UNITED STATES
NUCLEAR REGULATORY COMMISSION
WASHINGTON, D. C. 20555

Docket No. 50-213
LS05-85-07-026

SUBJECT: PROPOSED REVISION TO TECHNICAL SPECIFICATIONS CONCERNING THE
PRESSURE/TEMPERATURE LIMIT CURVES

Re: Haddam Neck Plant

Figure 3.4-1

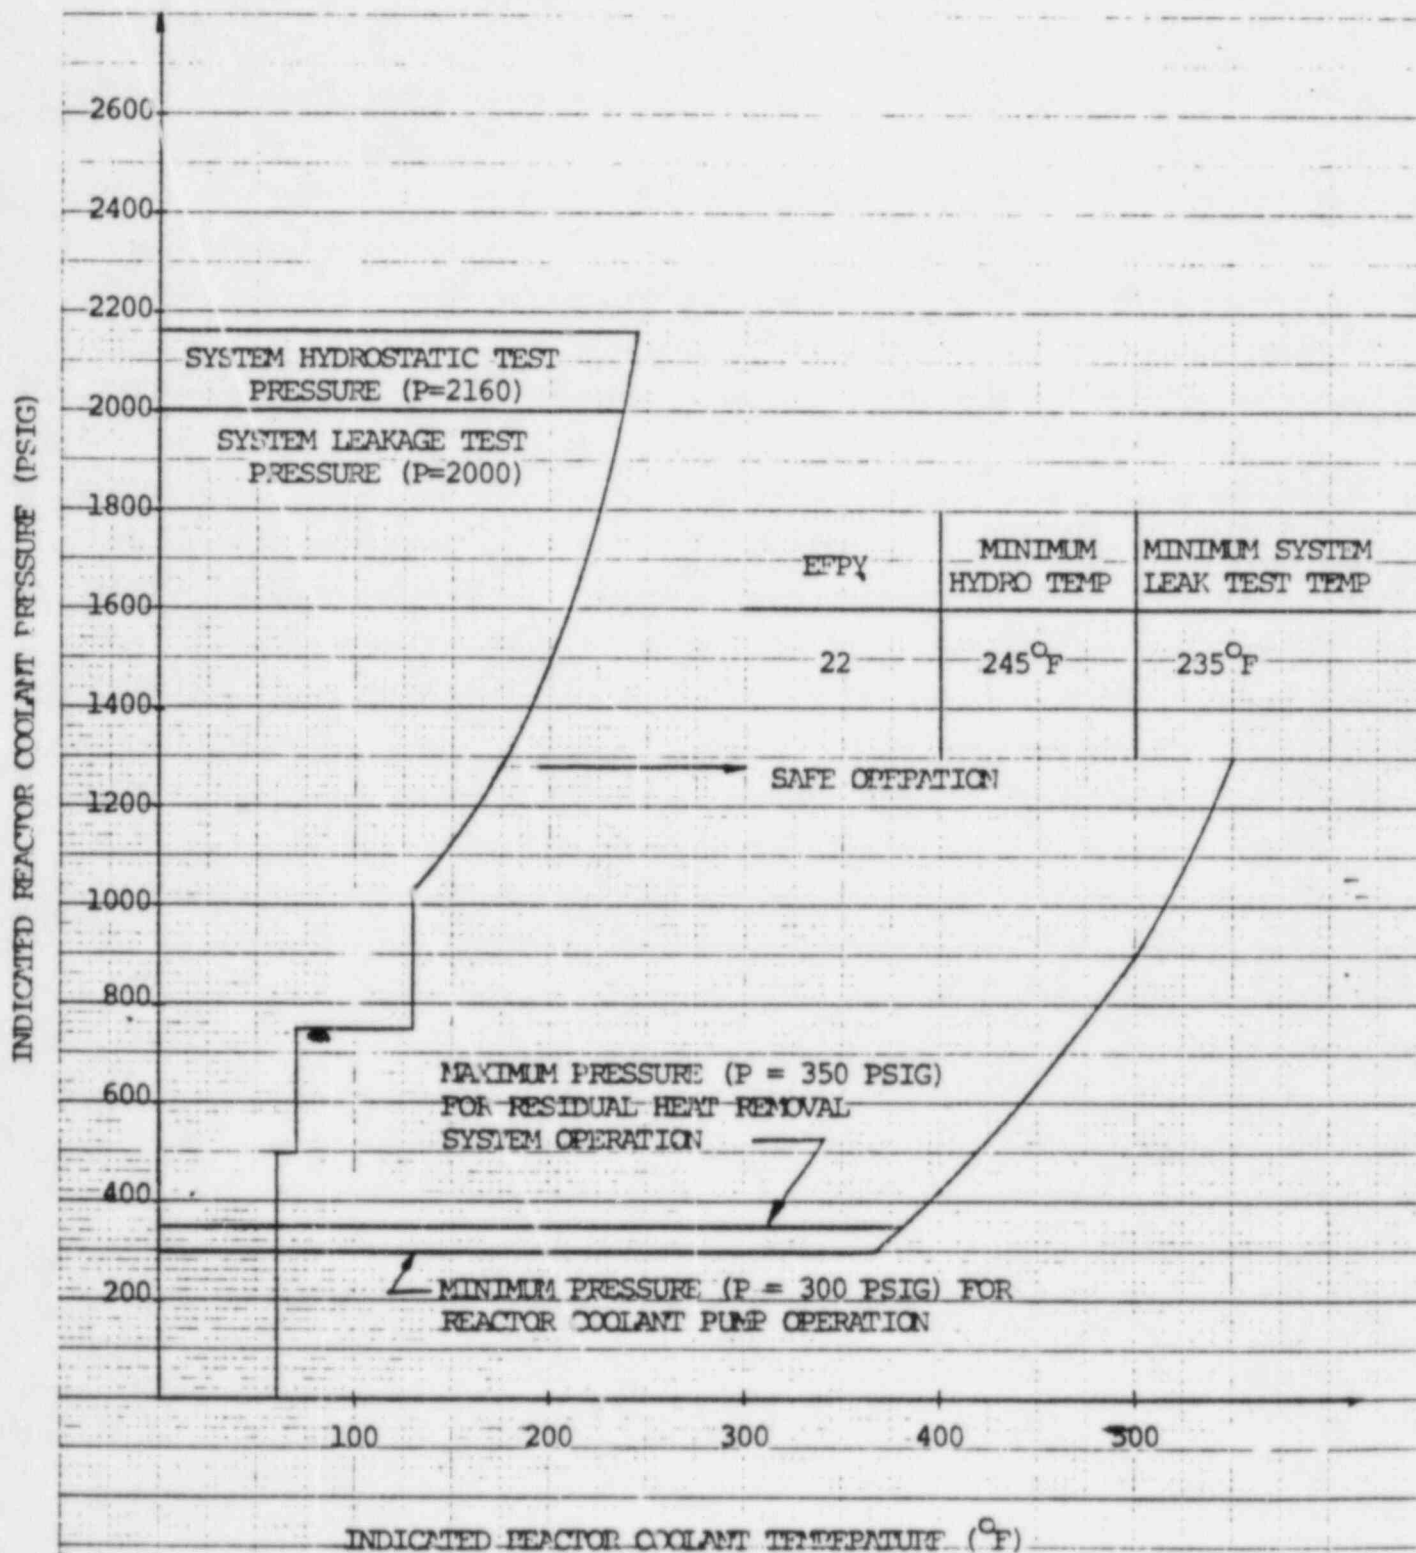
Given the licensee's commitment to be limited by the revised curves and given that the staff has reviewed the revised curves and concluded that the revised curves satisfied the requirements of 10 CFR Part 50, Appendix G, we conclude that the licensee satisfies the requirements of 10 CFR 50.60 and Appendix G. We will continue to work as rapidly as possible to assure the prompt issuance of the requested license amendment.

However, pending issuance of the amendment, you are hereby required, in accordance with 50.54(f), to notify us in writing within 48 hours of any violation of the revised curves submitted by letter dated July 17, 1985. The curves of your July 17, 1985 letter have been attached to this letter.
